GILA RIVER BASIN
NEW RIVER
AND PHOENIX CITY STREAMS
ARIZONA

FINAL
ENVIRONMENTAL STATEMENT

DREAMY DRAW DAM
MARICOPA COUNTY, ARIZONA

March 1972

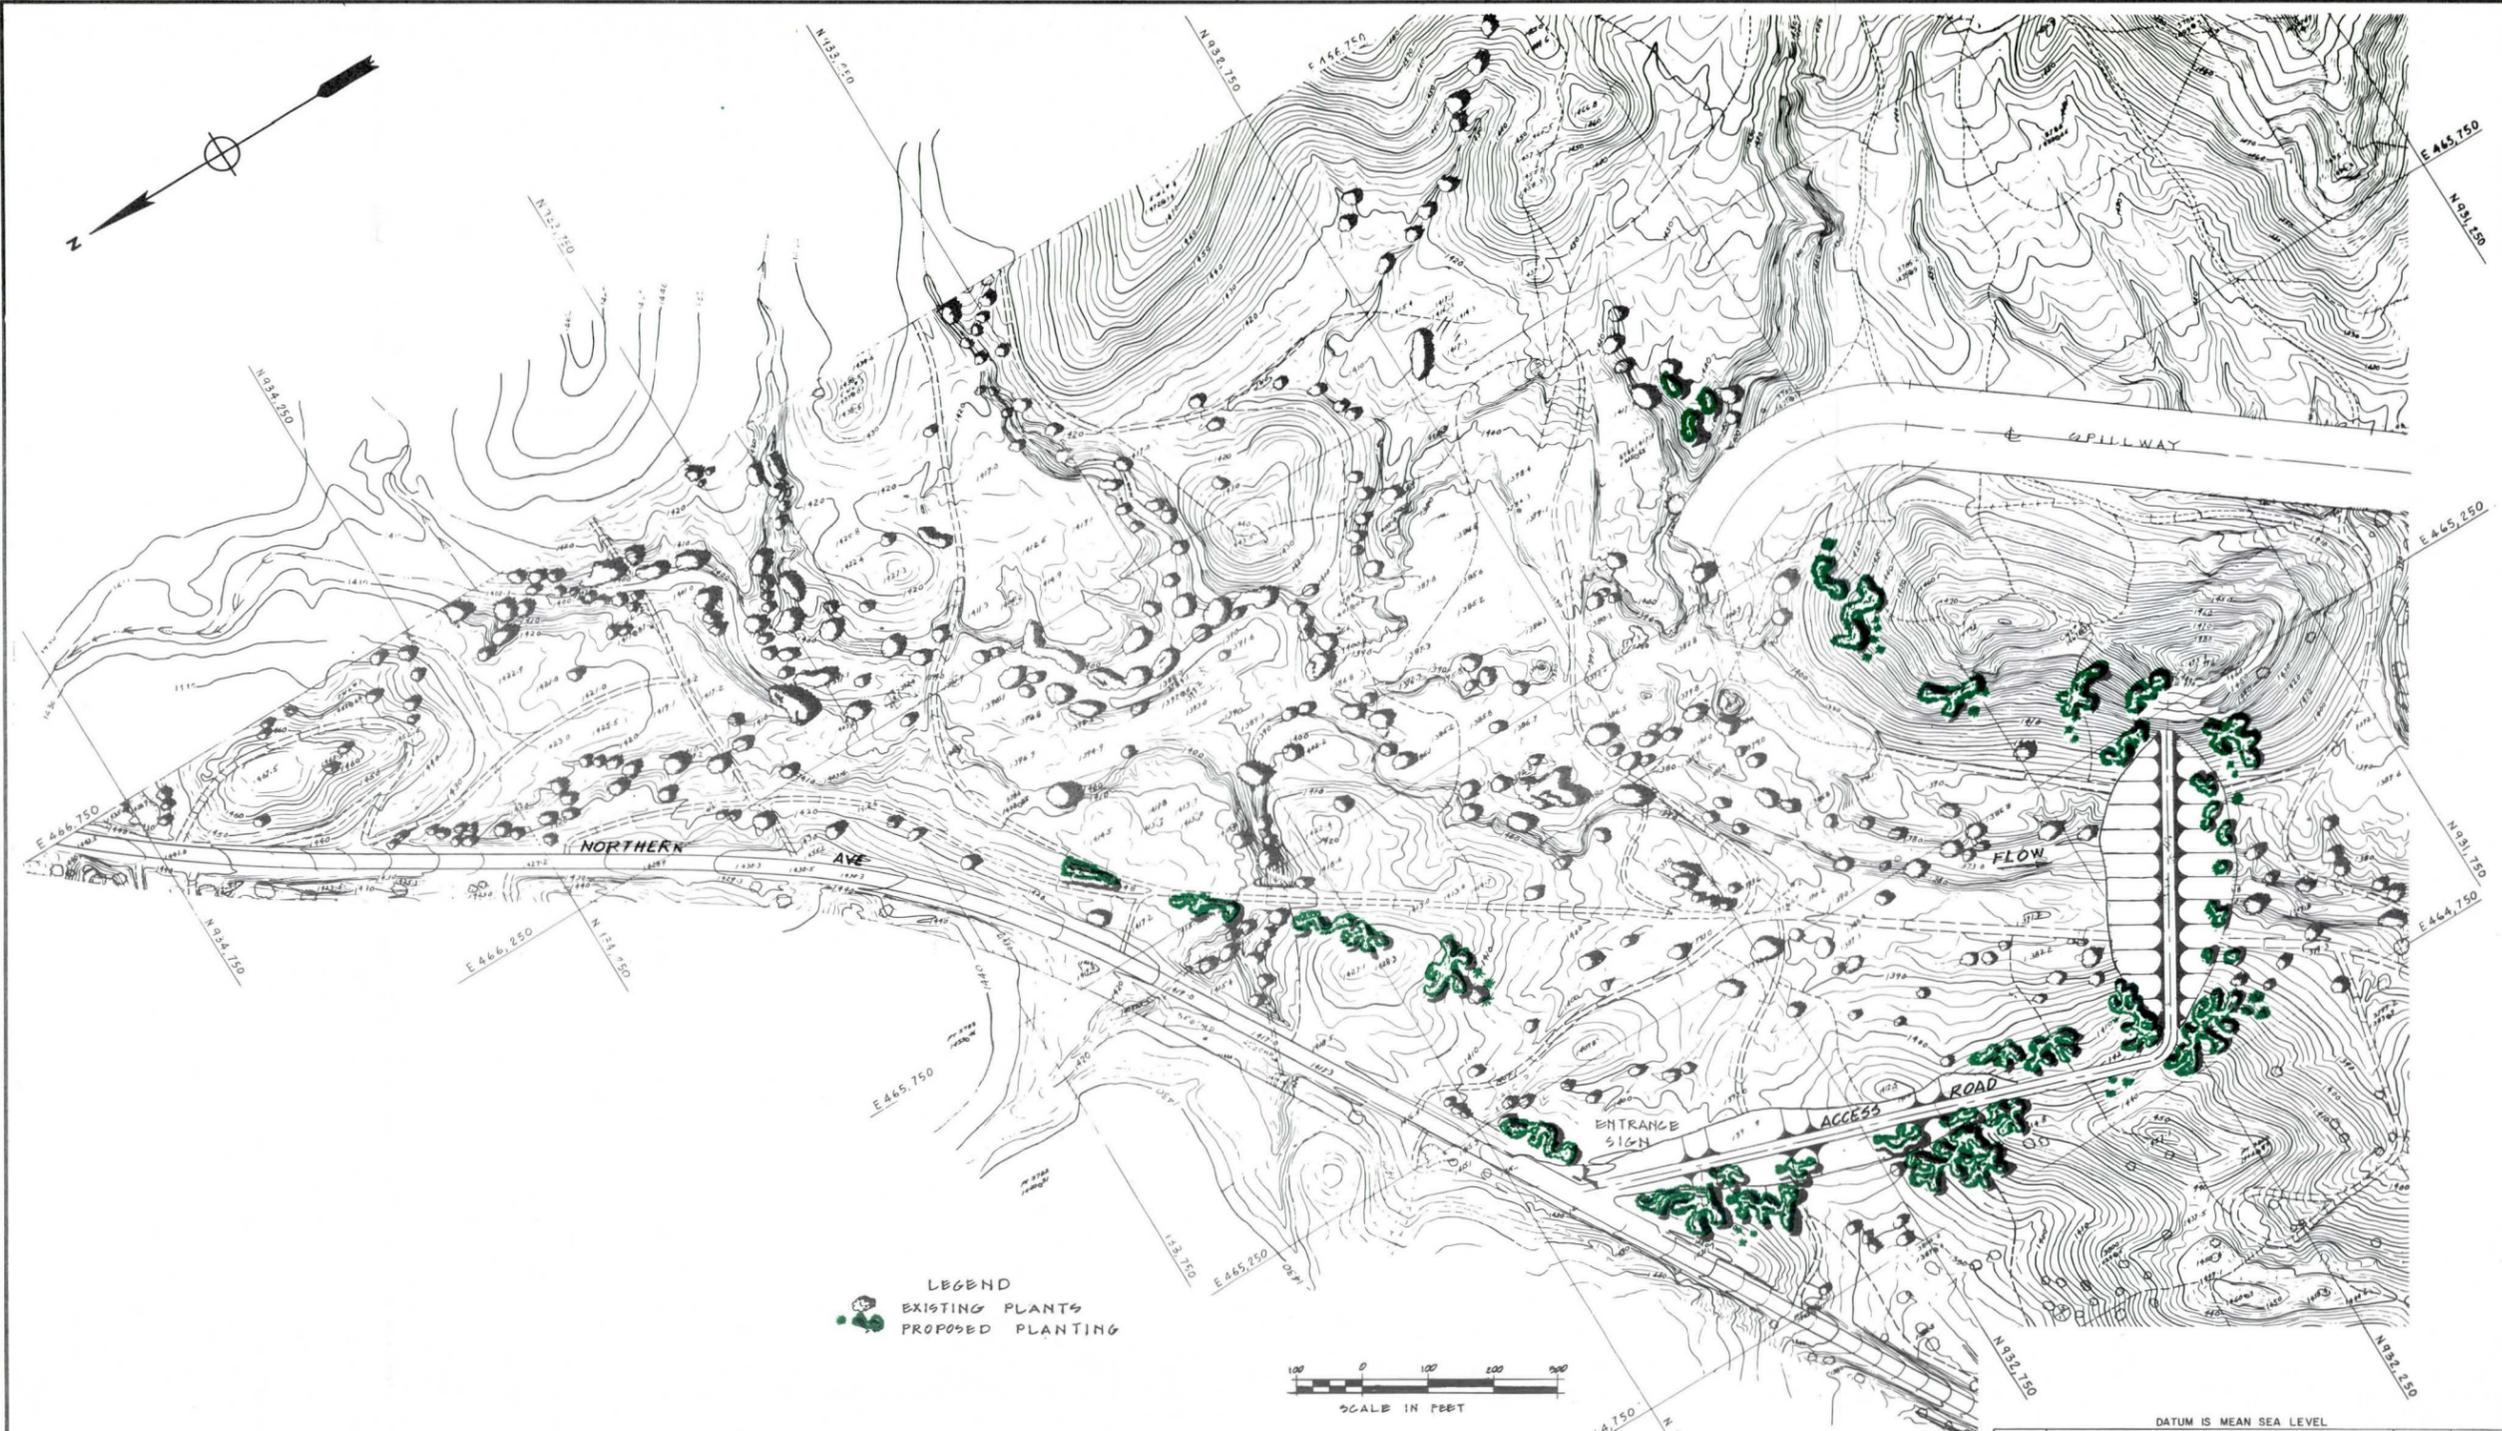
Comment: It is noted that your beautification plan dated February 1971, provides for a substantial amount of landscaping work. As previously indicated to Colonel Lowry of the Flood Control District and Major Chapman of the Corps of Engineers, we recommend that the beautification plan be improved to include planting on the embankments.

Response: The beautification plan has been revised to include planting on the embankments.

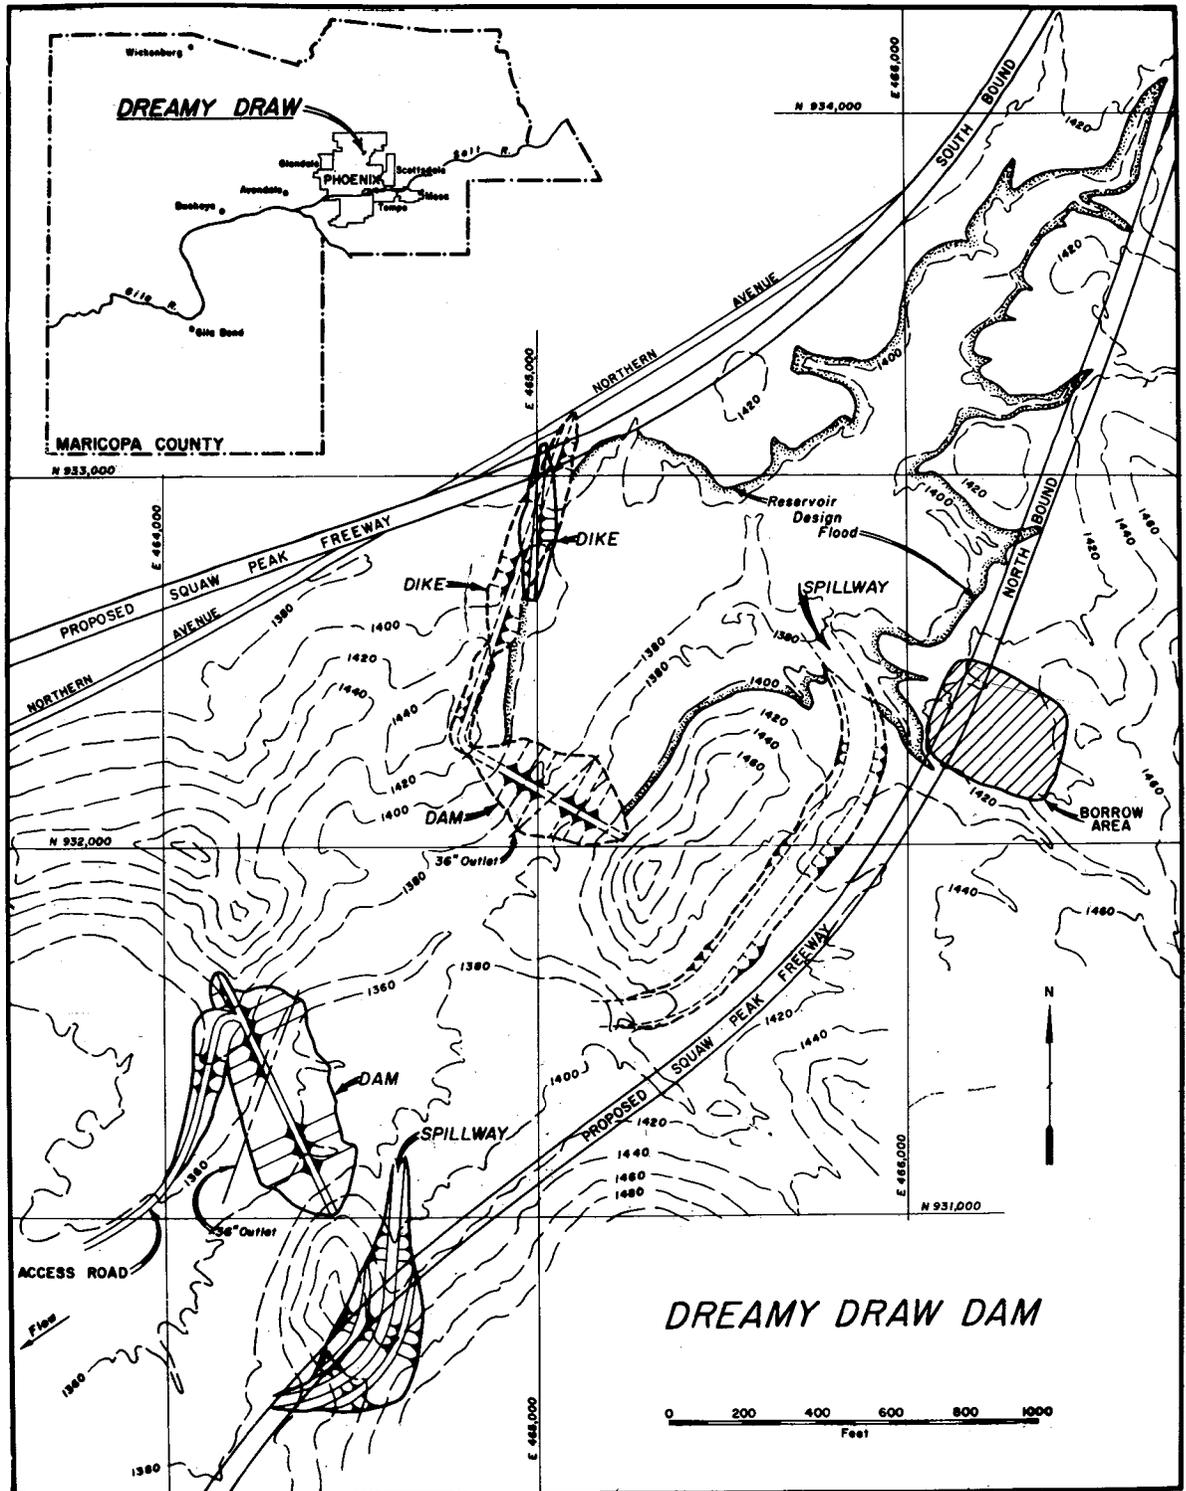
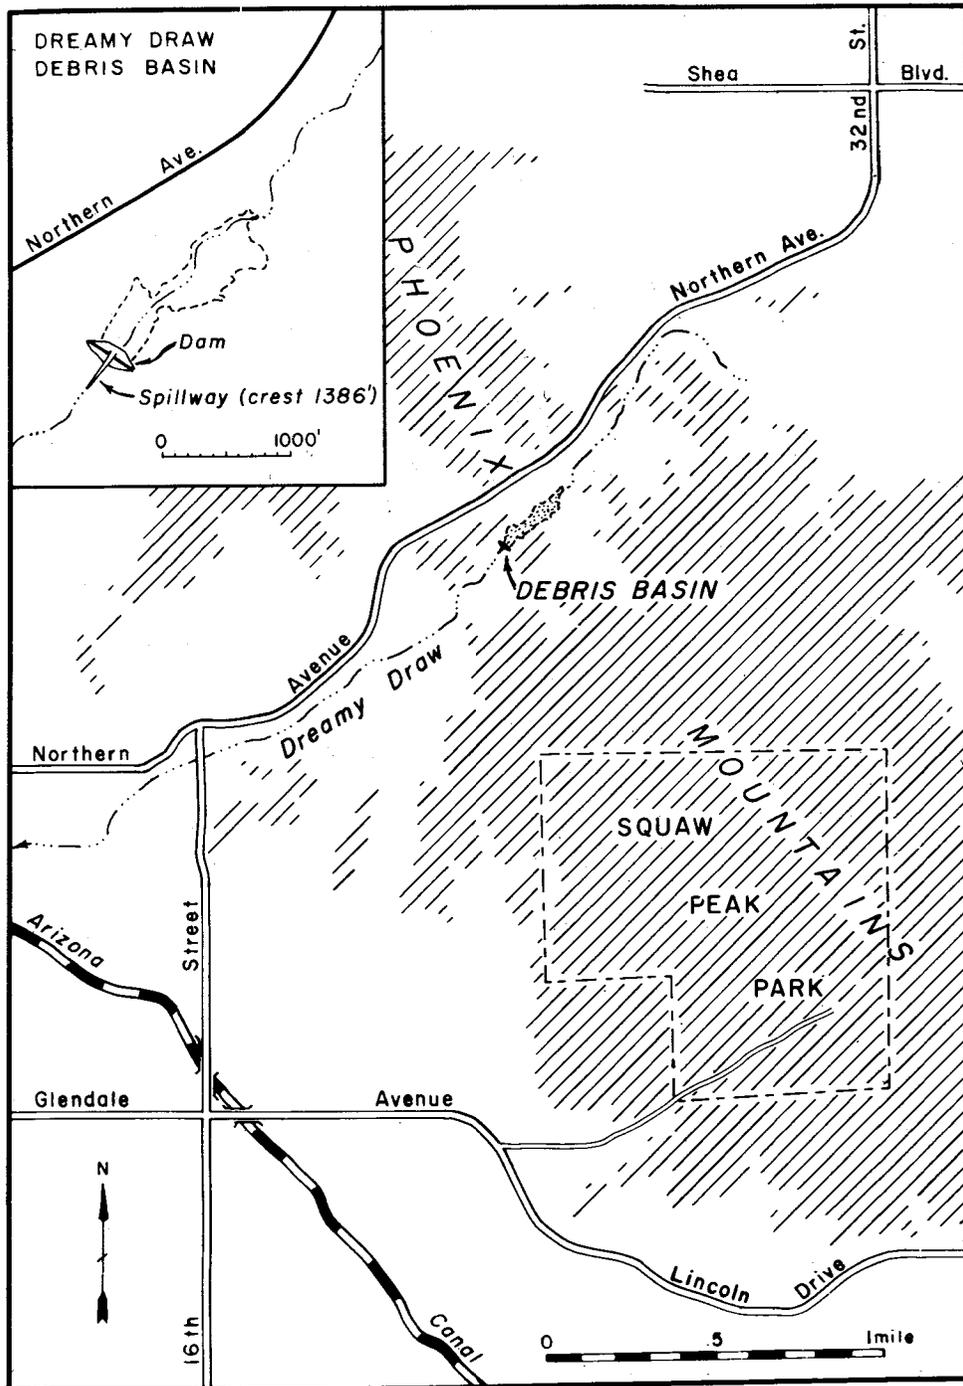
Comment: We find the draft environmental statement contains an adequate discussion of the project's effects upon water quality. The statement could be enhanced by inclusion of relevant drawings of the alternate plans considered.

Response: Figures have been added to the statement to show the location of the detention basin and debris basin alternative plans.
